**Intel[®] 82371AB PIIX4,
Intel[®] 82371EB PIIX4E,
Intel[®] 82371MB PIIX4M**

Specification Update

January 2002

Document Number: **297738-017**

TD CONTROL AND STATUS (DWORD 1: 04-07h)

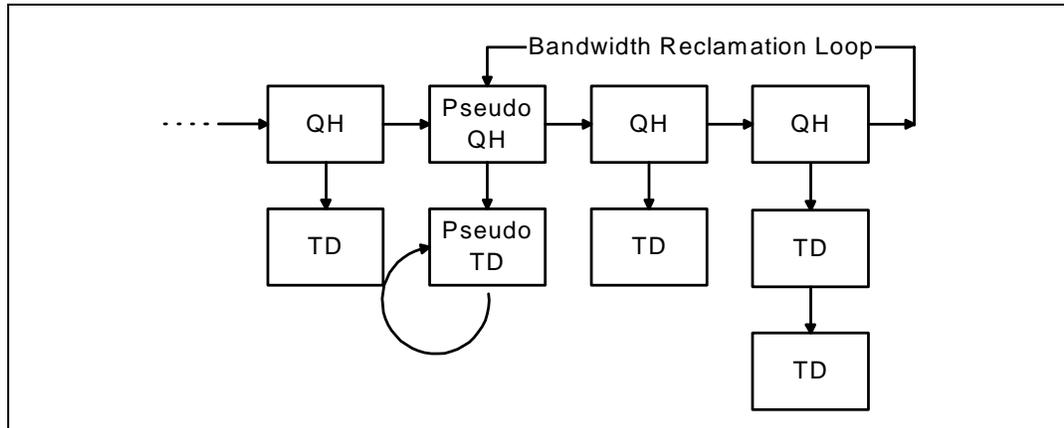
The Active status bit (bit 23) must be left unset at 0 indicating that the PIIX4/PIIX4E/PIIX4M should not execute this TD.

QUEUE HEAD LINK POINTER (DWORD 0: 00-03h)

The Queue Head Link Pointer (QHLP=bits [31:4]) must be set to point to the pseudo TD.
